UNITED STATES PATENT AND TRADEMARK OFFICE

APPLICATION NO.	FILING DATE	FIRST NAMED INVENTOR	ATTORNEY DOCKET NO.	CONFIRMATION NO.
10/046,285	01/16/2002	Jae Sung Kim	RPL-0025	2364

Office Action Summary

DETAILED ACTION

Fig. 4

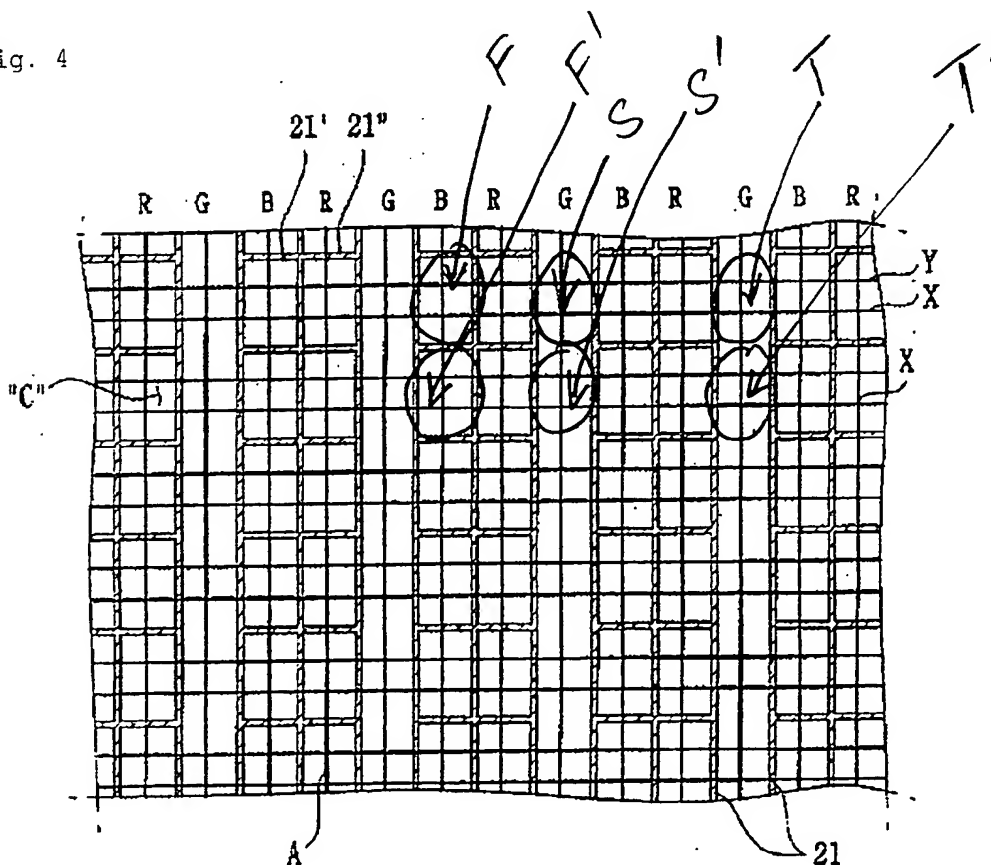
Regarding claims 9-11, the admitted prior art shown in figure 4 clearly discloses plasma display device comprising:

three sets of discharge cells are separated by barriers;

each cell of first blue discharge cells (F, marked by examiner) is separated from another adjacent cell of the first blue discharge cells (F', marked by examiner);

each cell of second set of discharge cells (S, marked by examiner) is separated from another adjacent cell of the second discharge cells (S', marked by examiner); and

each cell of third set of discharge cells (T, marked by examiner) is separated from another adjacent cell of the first blue discharge cell (T', marked by examiner).
